## **A D SUBDIVISION**

APPLICATION NUMBER 10 DATE May 1, 2008

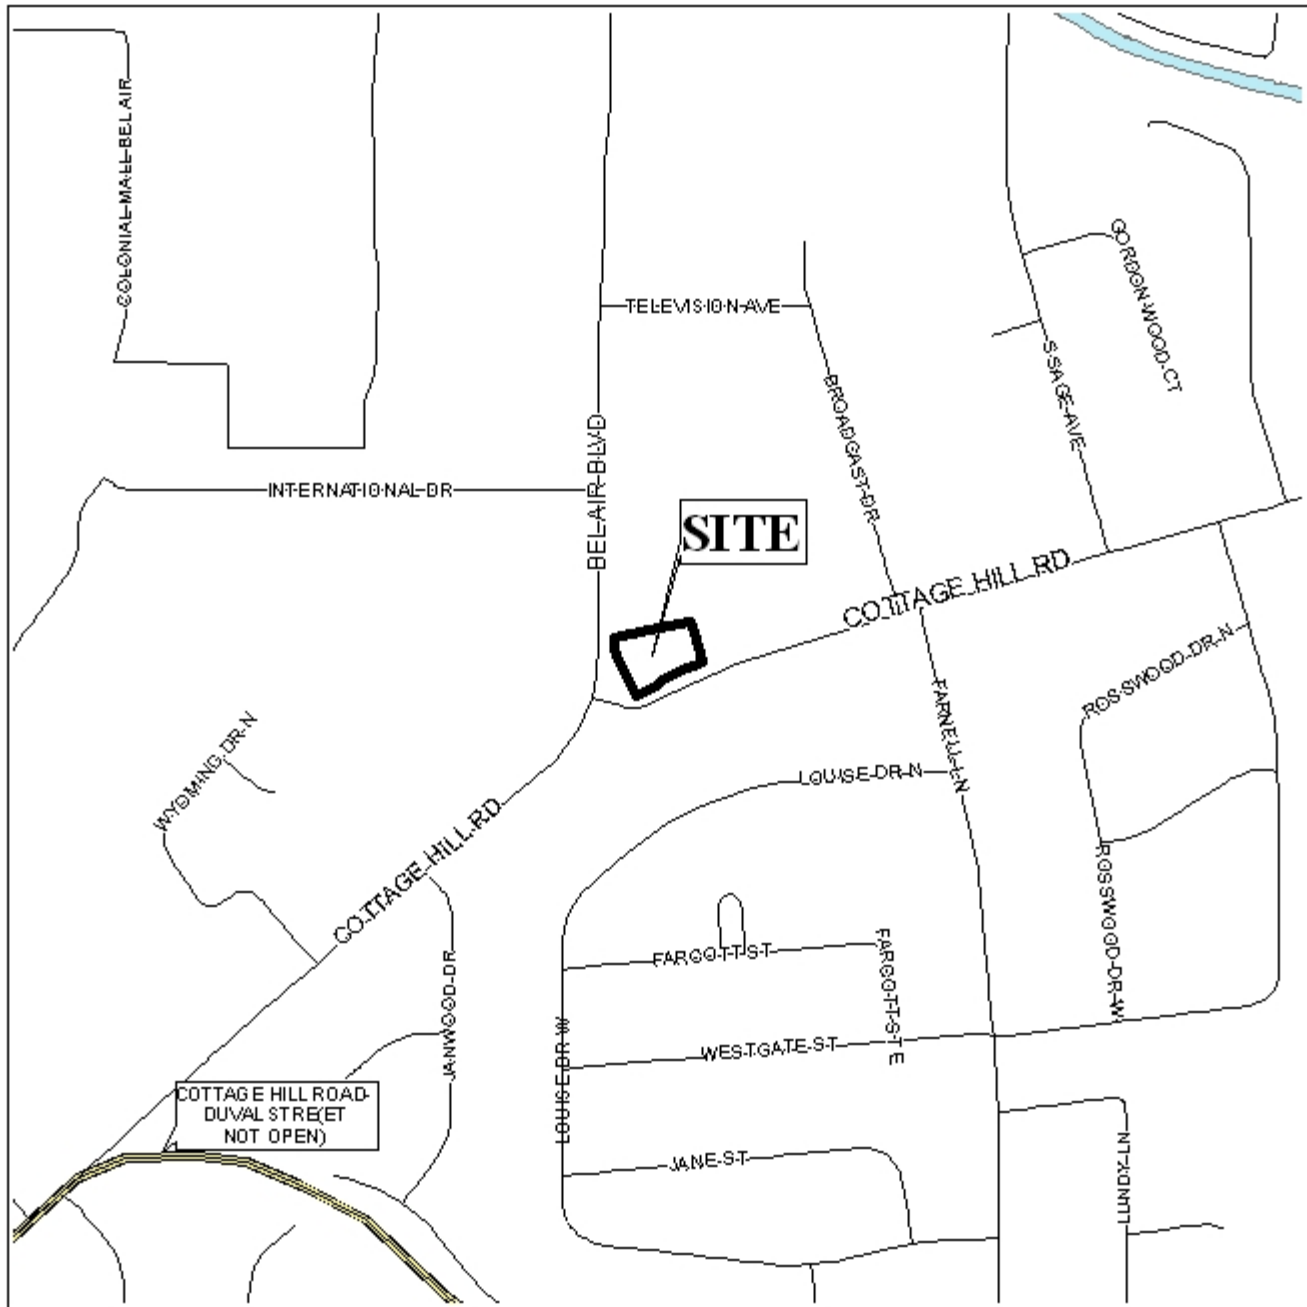
The site fronts both Bel Air Boulevard and Cottage Hill Road, both of which appear to have adequate right-of-way however, the right-of-way widths are not labeled, as required by section IV.A.2.d of the Subdivision Regulations. While the right-of-way may be adequate, the corner should be modified to comply with section V.D.6 of the Subdivision Regulations. The plat illustrates the required 25' minimum building setback line on both street frontages. This should also be depicted on the final plat.

Lot 1 will have approximately 200' of frontage onto Cottage Hill Road and 175' of frontage onto Bel Air Boulevard. The existing site has three curb cuts, but these are not depicted on the preliminary plat. Due to traffic in the area, and proximity to the intersection, Lot 1 should be limited to one curb cut to Cottage Hill Road and one curb cut to Bel Air Boulevard with the size, design and location to be approved by Traffic Engineering and conform to AASHTO standards.

In addition, the lot size in square footage should be labeled on the final plat.

- 1) depiction and labeling of the 25' minimum building setback line as shown on the preliminary plat;
- 2) labeling of the lot with its size in square feet, or provision of a table on the plat depicting the same information;
- 3) placement of a note on the final plat stating that Lot 1 is limited to one curb cut to Cottage Hill Road and one curb cut to Bel Air Boulevard, with the size, design, and location to be approved by Traffic Engineering and conform to AASHTO standards;
- 4) placement of a note on the plat stating that the site must be developed in compliance with all local, state and Federal regulations regarding endangered, threatened or otherwise protected species;
- 5) labeling of right-of-way widths, as required by the subdivision regulations; and
- 6) corner radius dedication to comply with section V.D.6 of the Subdivision Regulations.
